Our Ref: 34073-001-02
Your Ref: MCUI 2454/2017

**INFORMATION REQUEST RESPONSE
APPLICATION FOR A DEVELOPMENT PERMIT FOR MATERIAL CHANGE OF USE FOR
EXTENSION TO EXISTING INDOOR SPORT AND ENTERTAINMENT (THE PORT DOUGLAS DISTRICT
COMBINED CLUBS INC) TO PROVIDE RESTAURANT EXTENSION
7 ASHFORD AVENUE, PORT DOUGLAS - LEASE F ON SR697 IN LOT 5 ON SP288958**

TITLE
PDCC0103
FIRST FLOOR PLAN

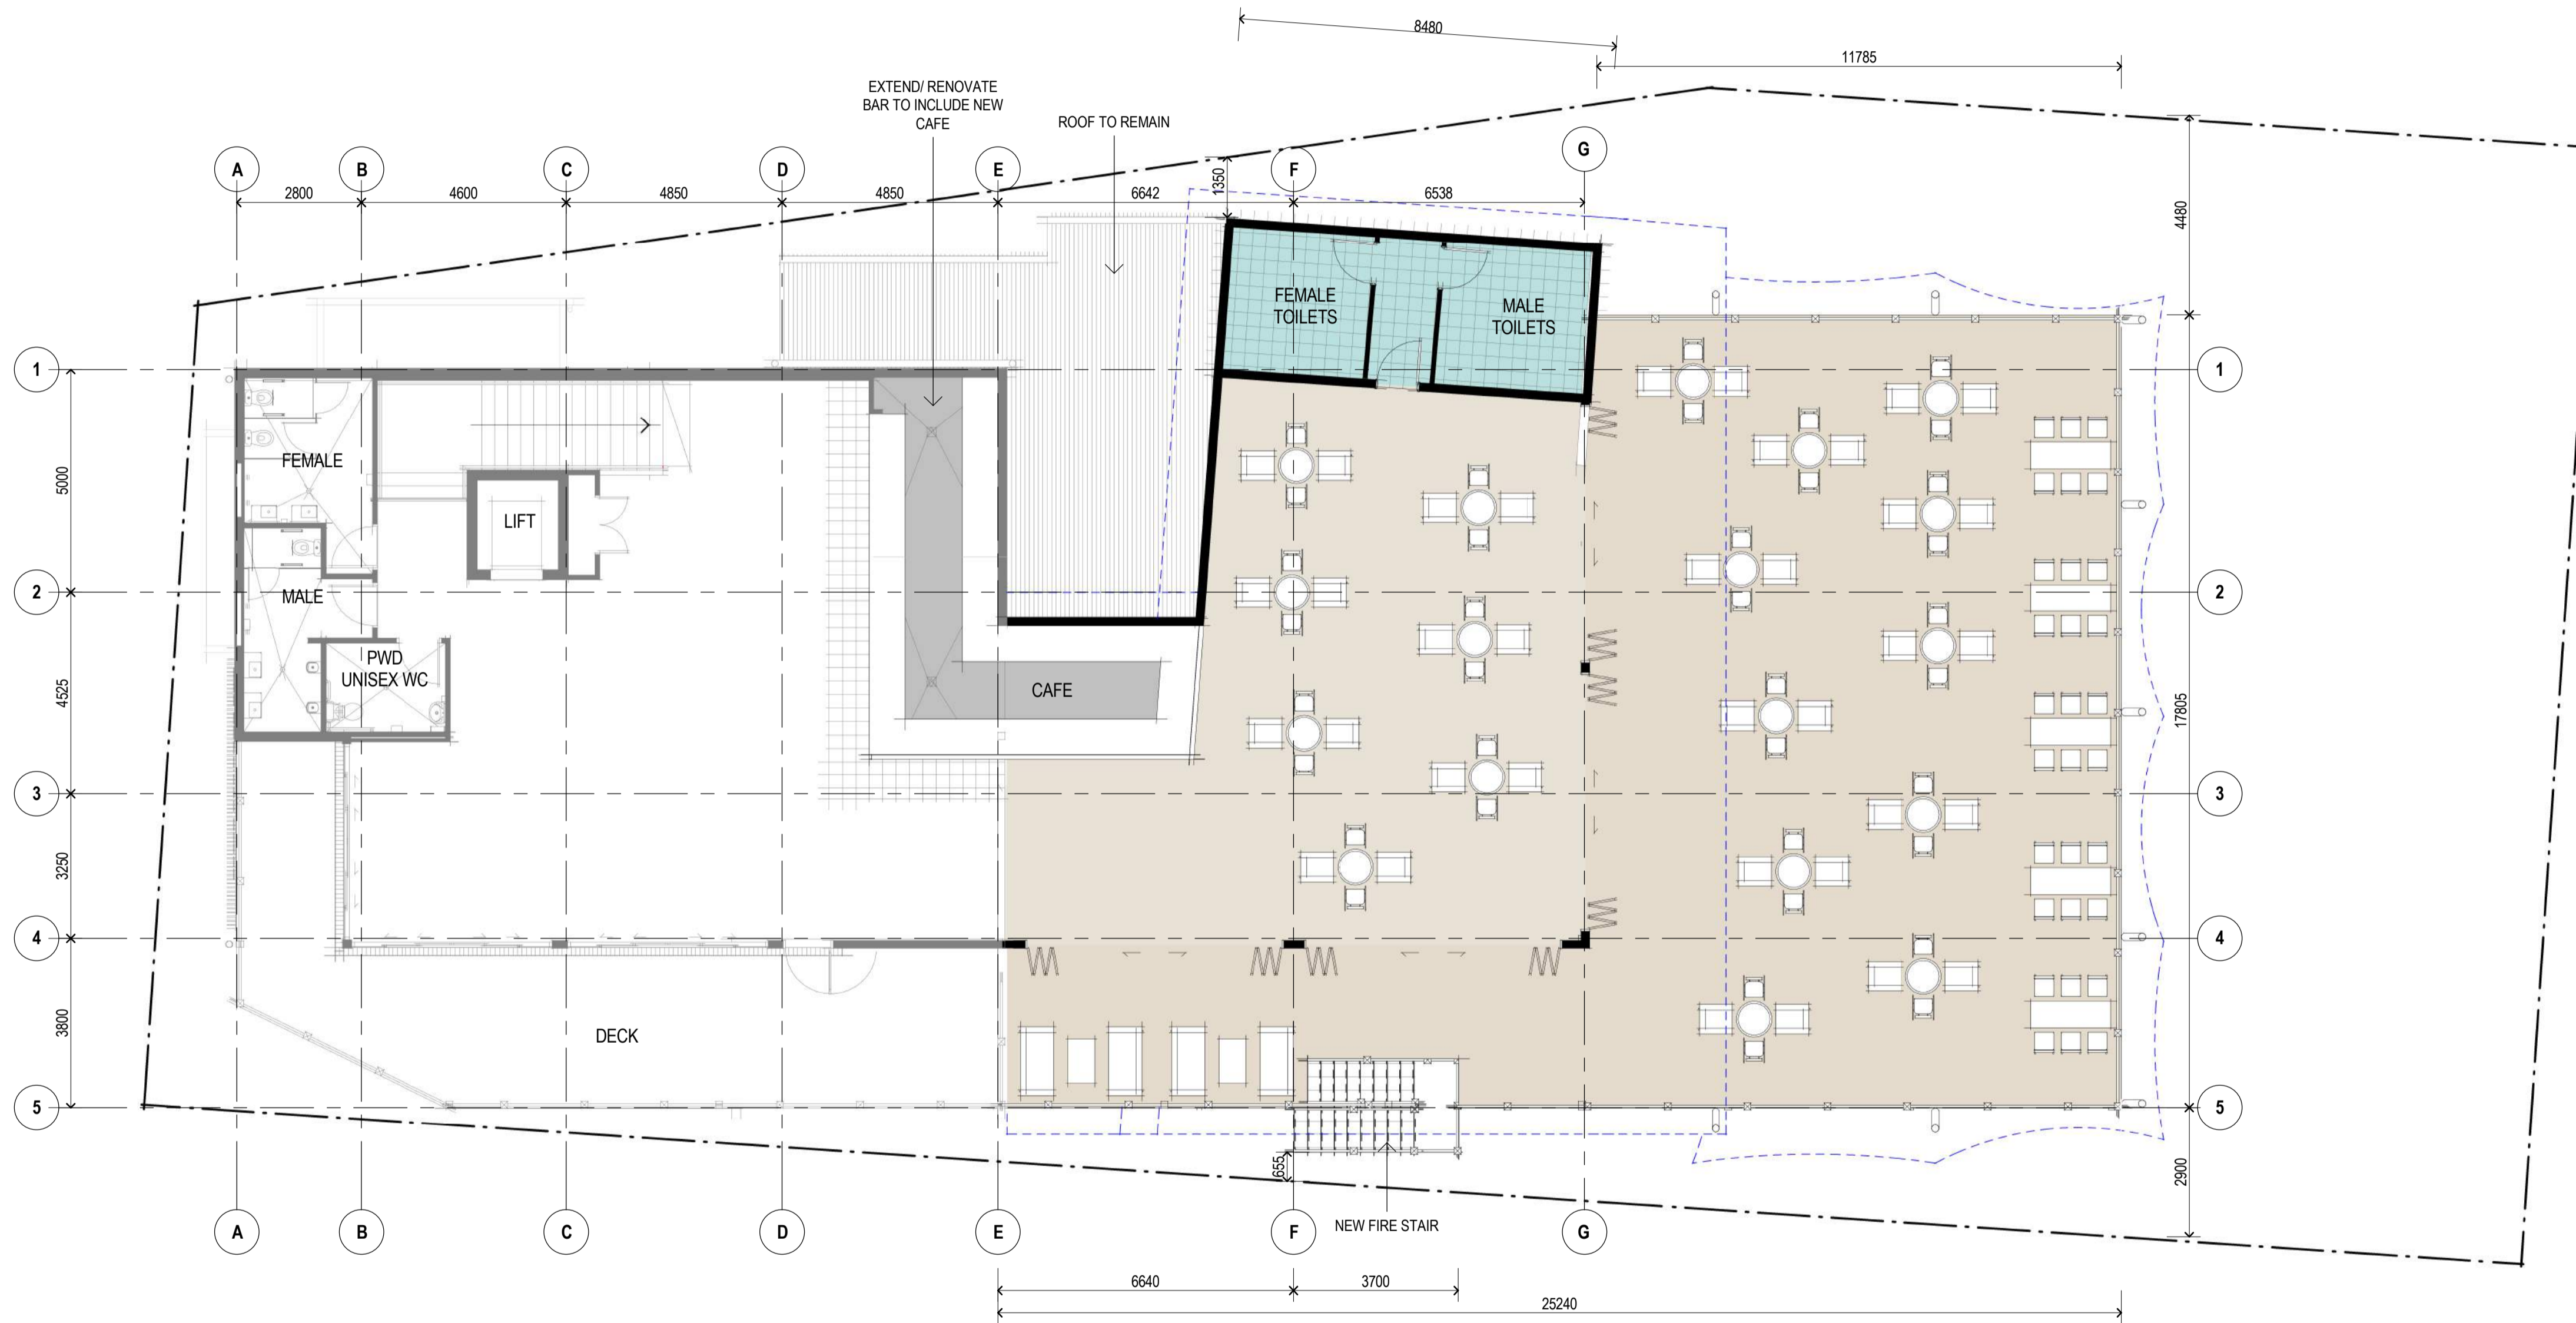
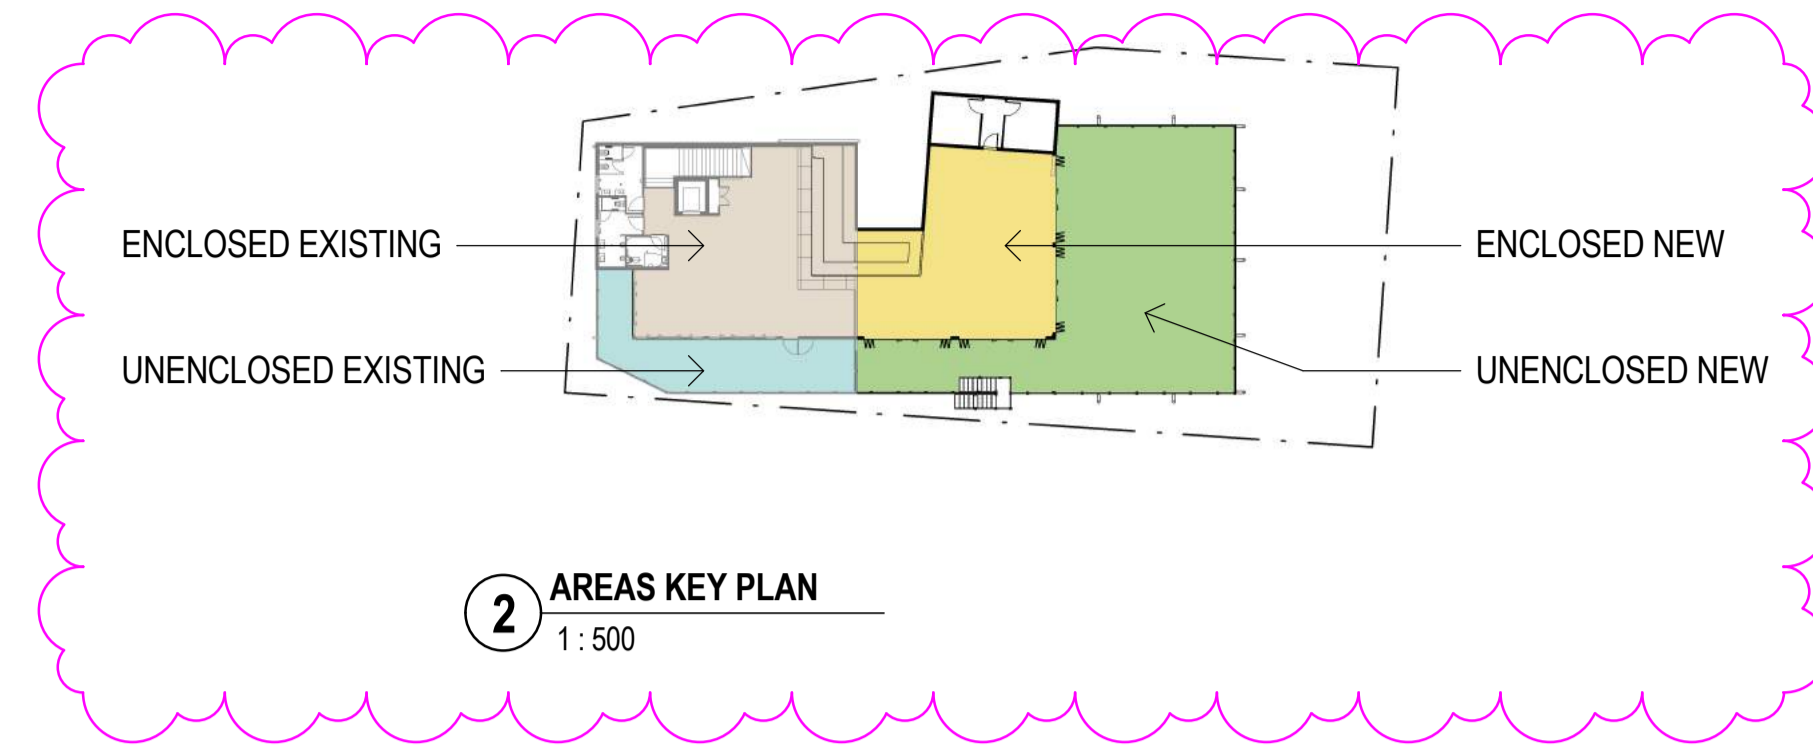
Drawing No PDCC0103 02-02 Rev A includes the following dimensions for the first floor extension:

Enclosed Area = 172m²
Unenclosed Area = 259m²
Total = 431m²

The Planning Report accompanying the application refers to the increase in area 'provided for the provision of meals and light refreshments on the first floor being 148m².'

Please reconcile this discrepancy providing Council with floor areas based on a Net Lettable Area as defined in the 2006 Douglas Shire Planning Scheme. It is noted that the proposed floor area is now more than double the size of the floor area presented to Council as a formal pre-lodgement enquiry in October 2017.

Please see enclosed (Attachment A) an amended plan (PDCC0103 Drawing No. 02-02 Revision B) confirming that the proposed additional floor area is 399m² NLA. There was an error in the planning report, which incorrectly identified that proposed additional floor area.

It is noted that since the pre-lodgement meeting in February 2017 and the pre-lodgement enquiry in October 2017, the Club decided to increase the extent of the unenclosed deck area on the first floor, hence the increase in proposed additional area.

TITLE
PDCC0103
FIRST FLOOR PLAN

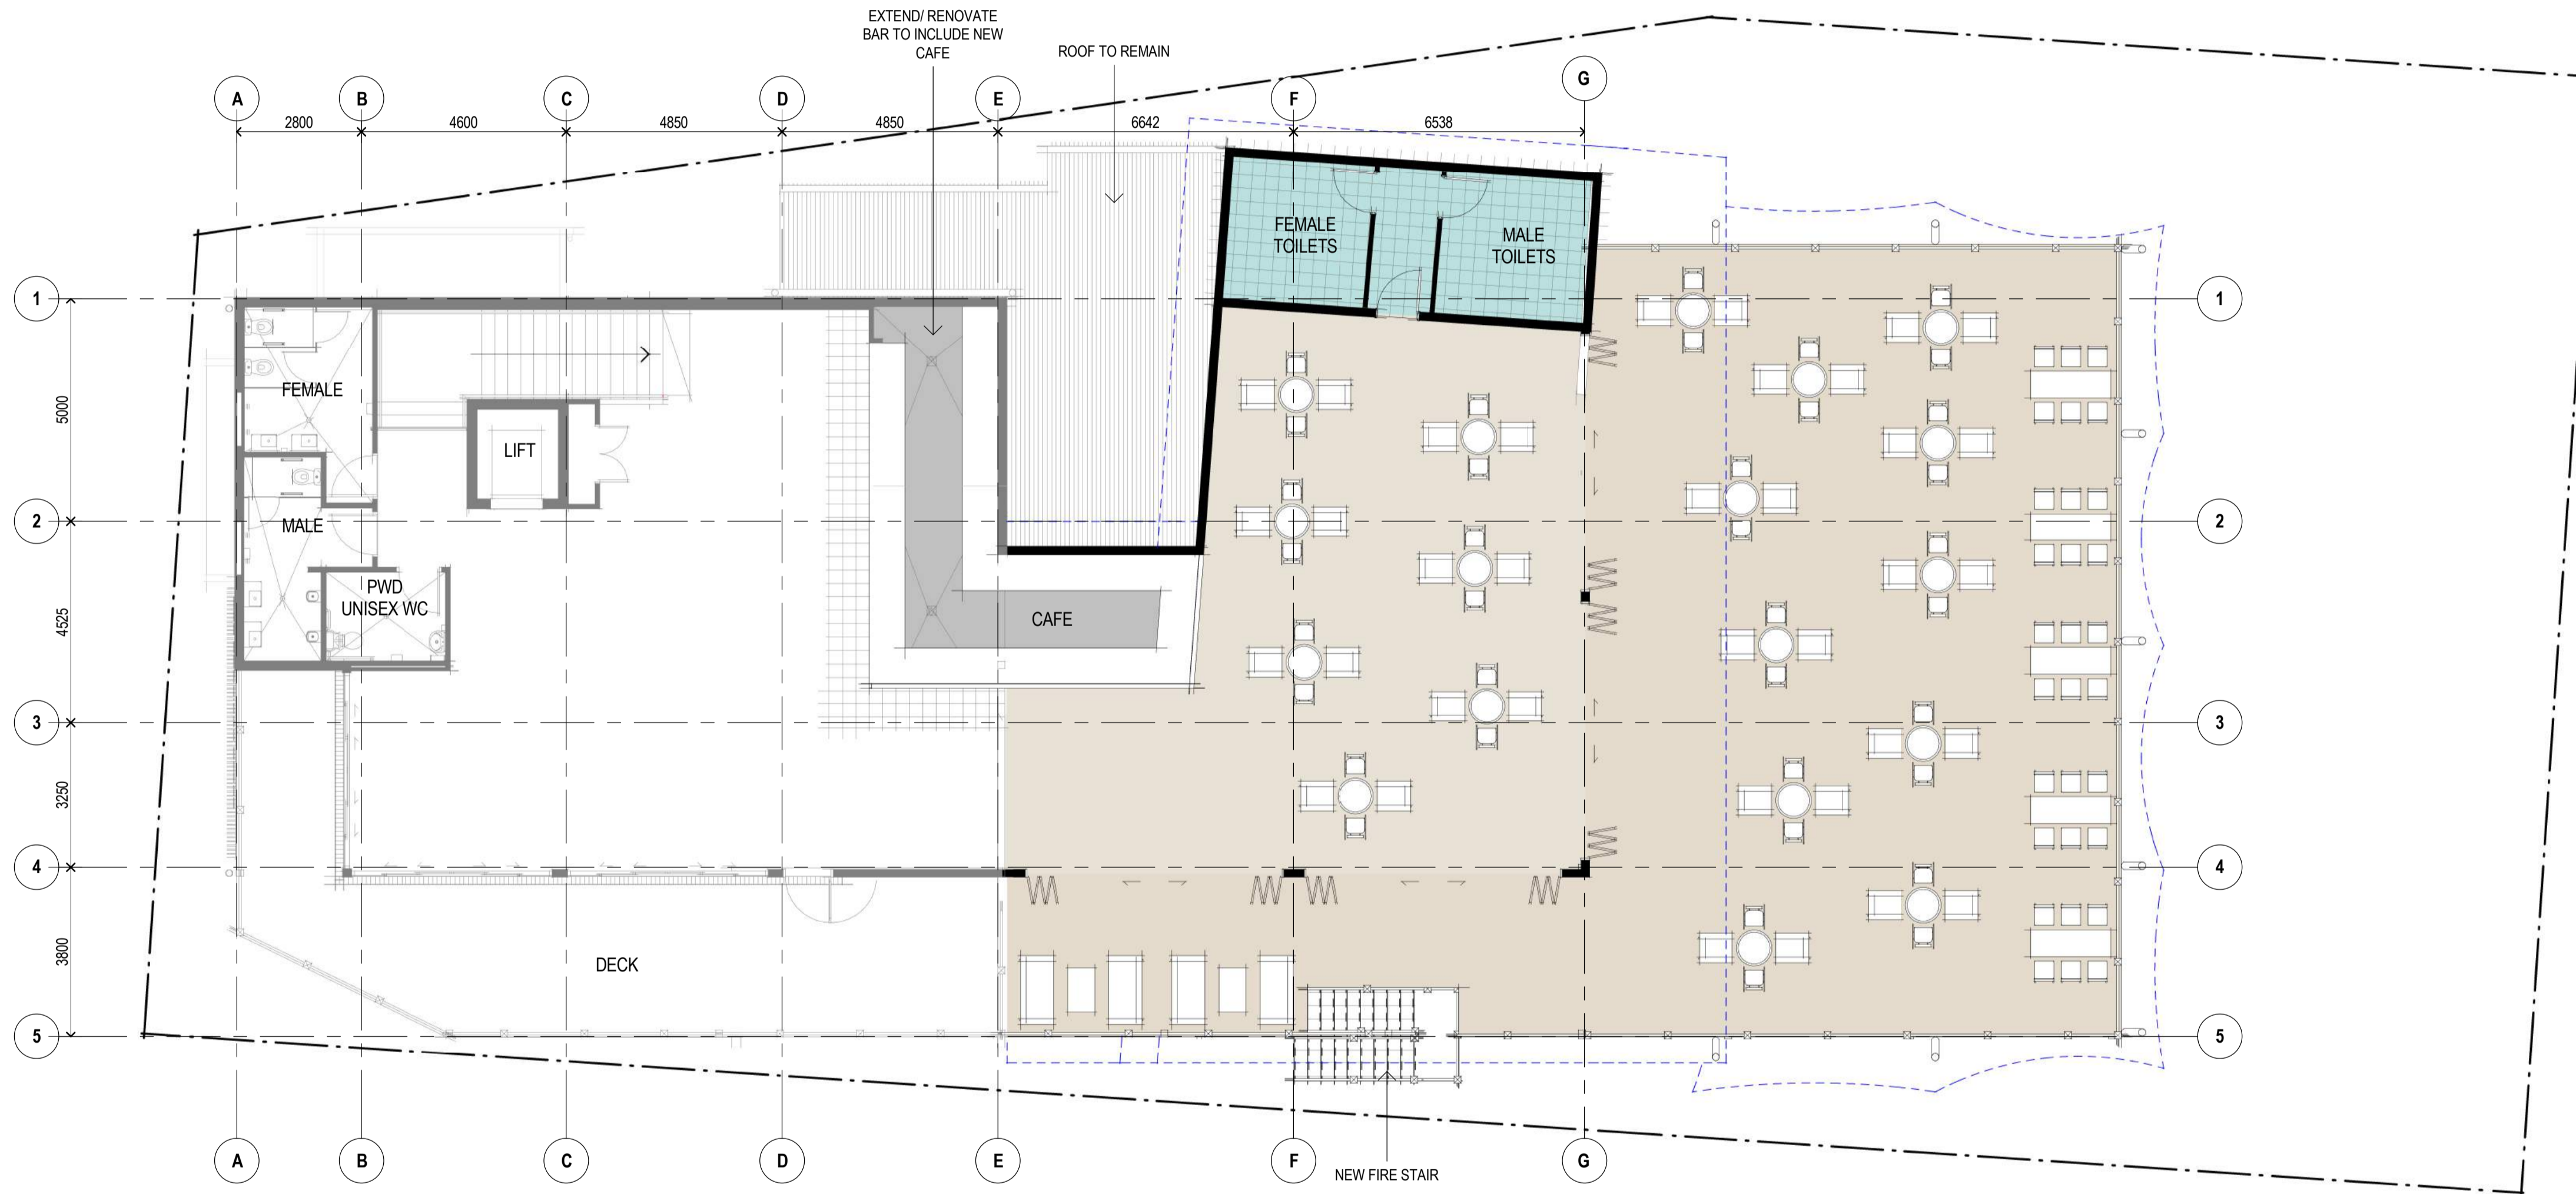
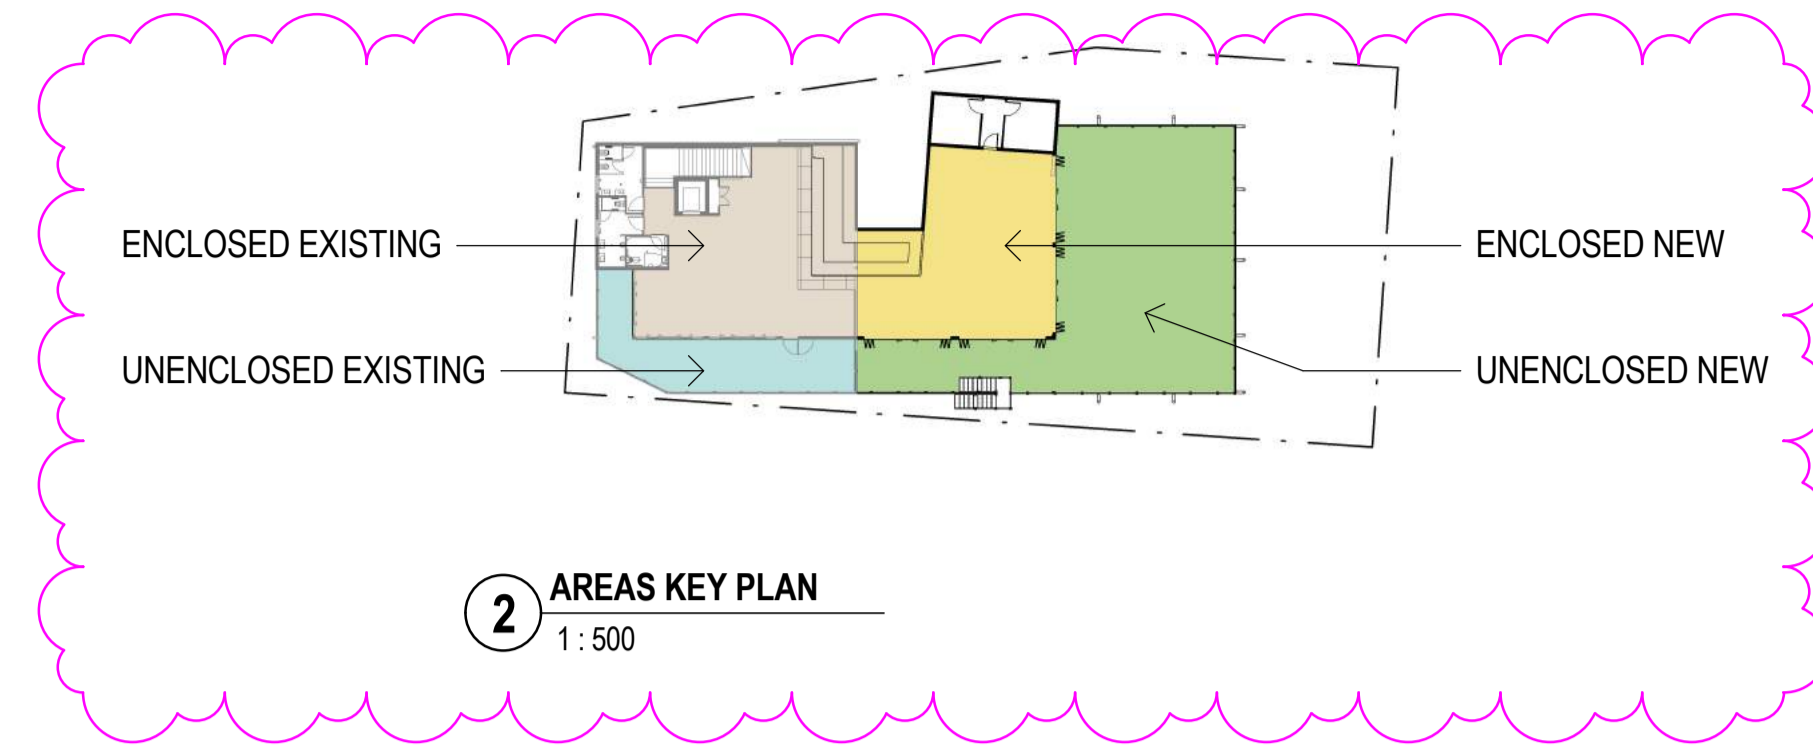
Provide an evidence based traffic study prepared by an appropriately qualified traffic consultant to fully justify any proposed car parking arrangements for the additional floor space. Little, if anything, contained in the planning report justified the extent of car parking relaxation. Not, patrons utilising the bar whilst waiting for a table reservation and then once dining has finished use the lounge or gaming lounge' is not a valid example of cross-utilisation.

The Port Douglas and District Combined Club is proposing an extension to the existing clubhouse which will result in *additional* floor space of the first floor of the club of 399m² Net Lettable Area (NLA). Details of the proposed extension of the first floor are illustrated on the attached plan prepared by Paynter Dixon (Dwg 02-02 Rev B).

Regardless, as specified in the Council's Vehicle Parking and Access Code of the Council's 2006 planning scheme, parking for a 'Restaurant' is required to be provided at a rate of 1 car space per 25m² NLA. Noting, as stated in Item 3 of the Information Request, the parking provision for the extension only relates to the *additional* floor space, a total of an additional **16 car park spaces** is required to be provided with the proposed extension.

In this context, given there are physical constraints which do not enable the opportunity to provide additional car park spaces immediately fronting the club, it is recommended the applicant be required to construct the shortfall of spaces (i.e. 16 spaces) in close proximity to the existing club (i.e. within 100/200m of the club). It is understood that the off-street parking area adjacent the club (bordered by Wharf Street and Grant Street) is a Council owned off-street car park which is available to the public when frequenting the Port Douglas business precinct.
